UNITED STATES PATENT AND TRADEMARK OFFICE

APPLICATION NO.	FILING DATE	FIRST NAMED INVENTOR	ATTORNEY DOCKET NO.	CONFIRMATION NO.
10/711,513	09/23/2004	Chi-Chan Chiang	CHEP0039USA	5512
27765	7590	05/12/2006	EXAMINER	
NORTH AMERICA INTELLECTUAL PROPERTY CORPORATION P.O. BOX 506 MERRIFIELD, VA 22116				COLILLA, DANIEL JAMES
ART UNIT		PAPER NUMBER		
				2854

Office Action Summary	Application No.	Applicant(s)	
	10/711,513	CHIANG, CHI-CHAN	
	Examiner	Art Unit	
	Daniel J. Colilla	2854

DETAILED ACTION

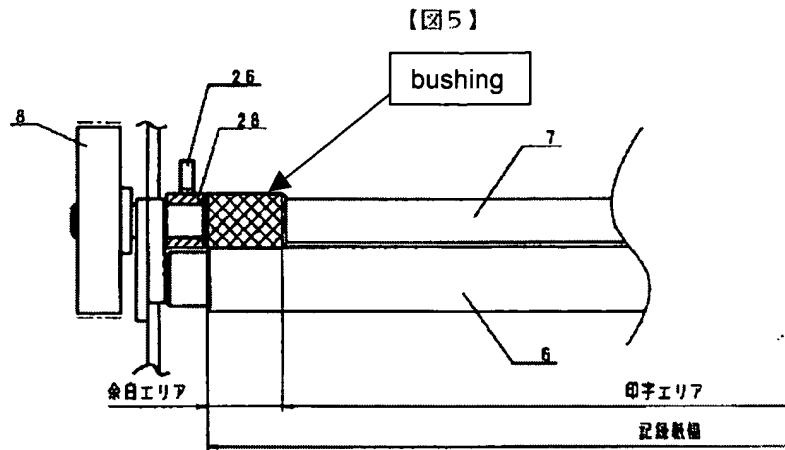
With respect to claim 6, Kanbe *et al.* discloses the claimed thermal printer except for the pinch roller driving device. Kanbe *et al.* discloses a capstan roller 7 and a pinch roller for pressing a print medium 4 to the capstan roller 7. As shown below, in the Figure taken from Figure 5 of Kanbe *et al.*, Kanbe *et al.* discloses a bushing installed around the capstan roller:

The outer radius of the bushing is greater than the radius of the capstan roller 7 so that there is a gap between the capstan roller 7 and the pinch roller 6 as shown above. Eshita teaches a pinch roller 44 driving device (see Figure 2 of Eshita) for pressing the pinch roller onto the print medium or separating the pinch roller from the print medium. It would have been obvious to combine the teaching of Eshita with the thermal printer disclosed by Kanbe *et al.* for the advantage of optimally setting the pinch roller position for whatever type of paper is being printed.
